SUPPLEMENT NO. 1

PHILIP R SMITH ELEMENTARY SCHOOL
GILBANE JOB NO. J07896.000
STATE PROJECT NO. 132-0089N

PRS-SI-0007

Owner Room Names and Signage

DWG. NO. **A1.5**

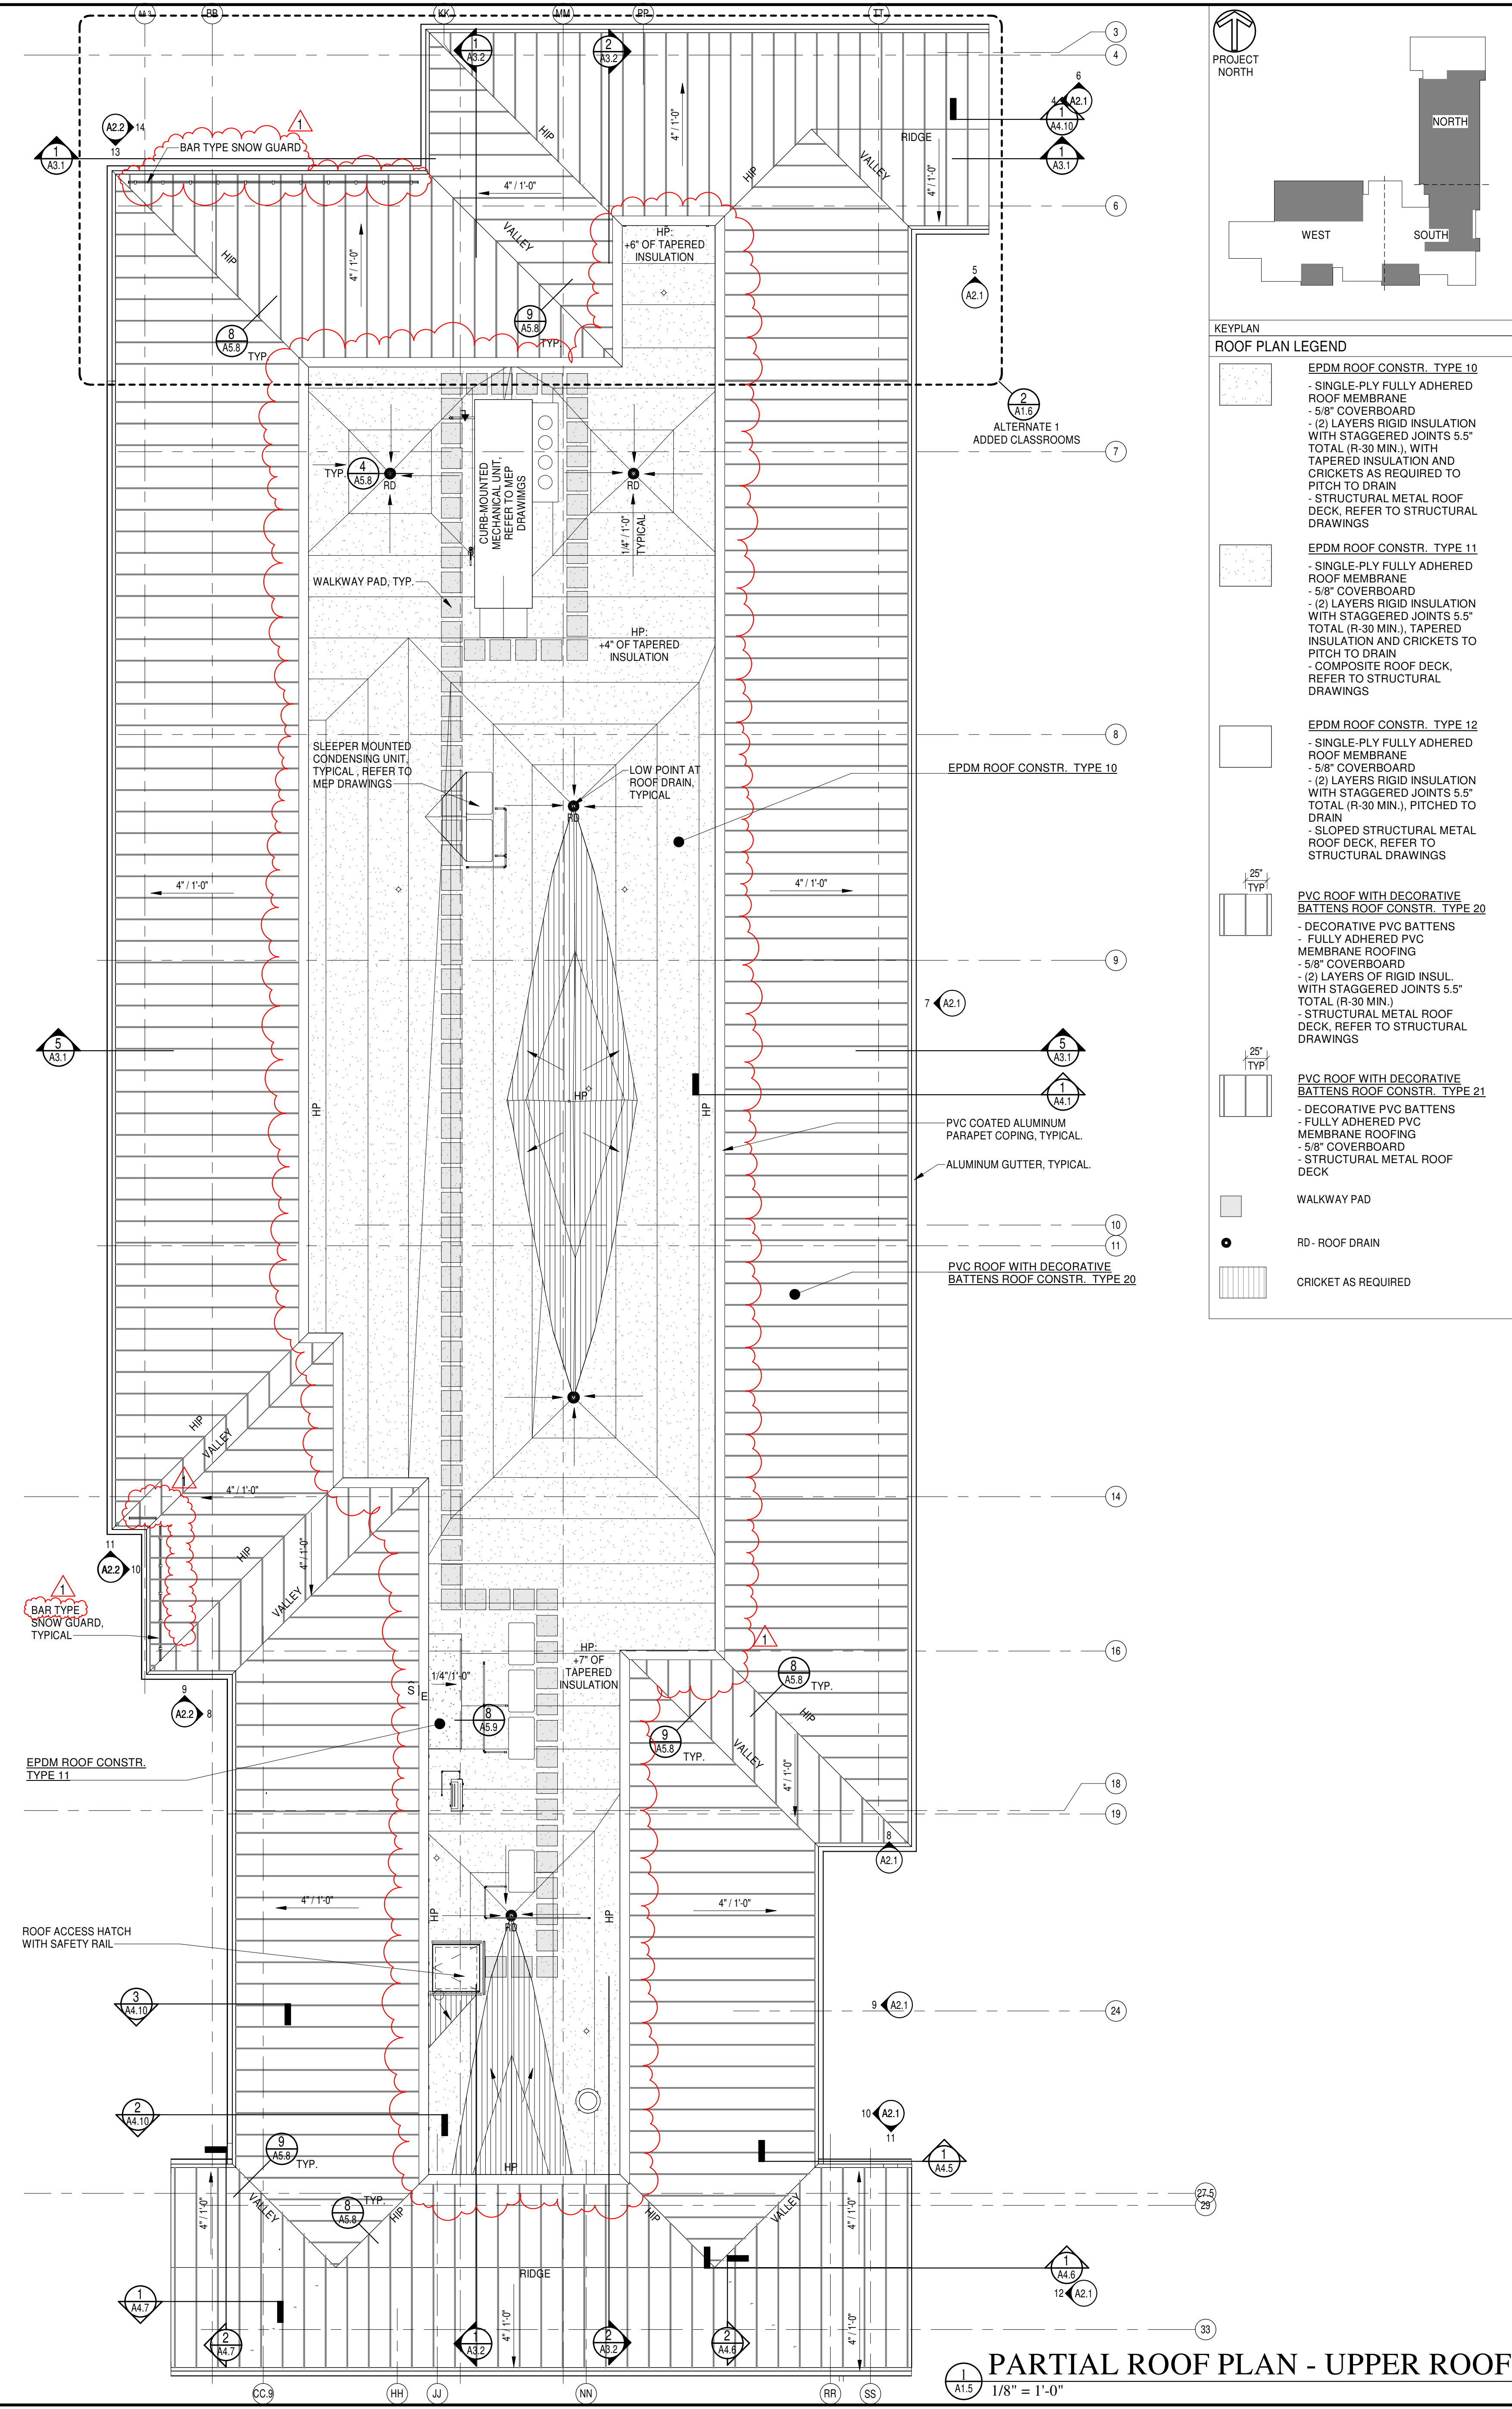
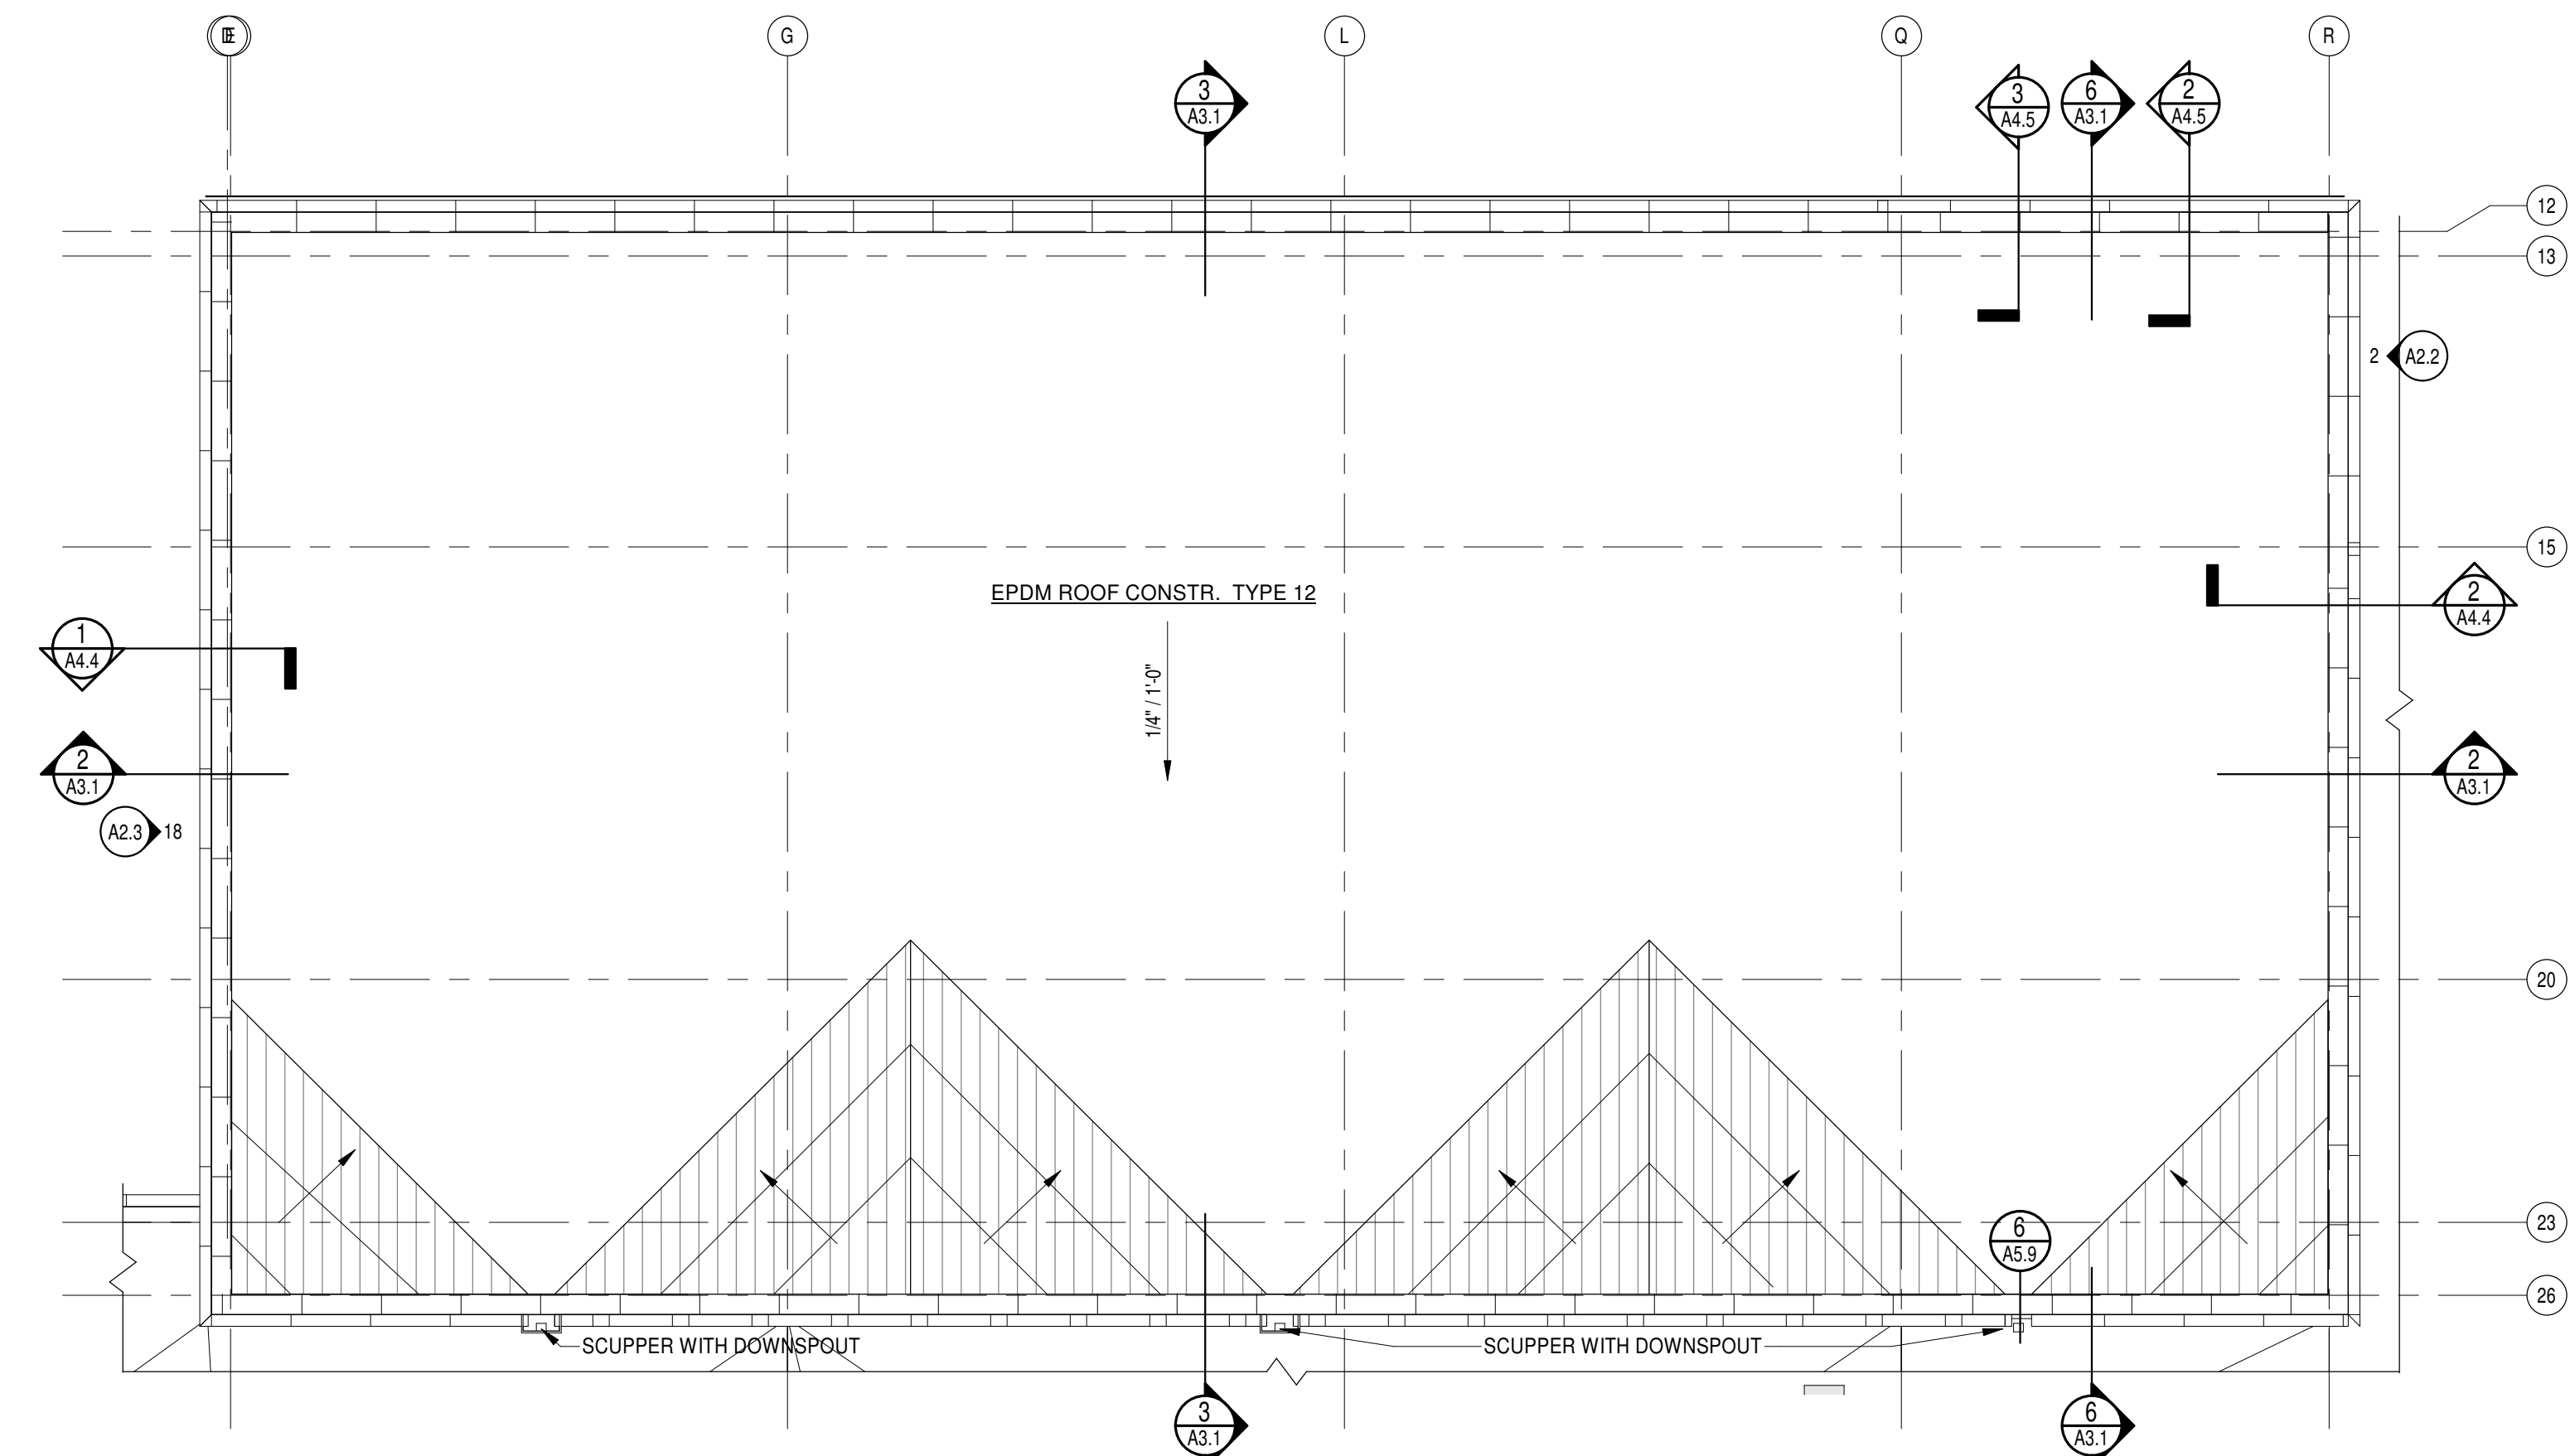
DRAWING A1.5 - PARTIAL UPPER ROOF CONSTRUCTION PLANS: **REMOVE** drawing as Issued for Bids and **REPLACE** with drawing attached to this Addendum with the following revisions:
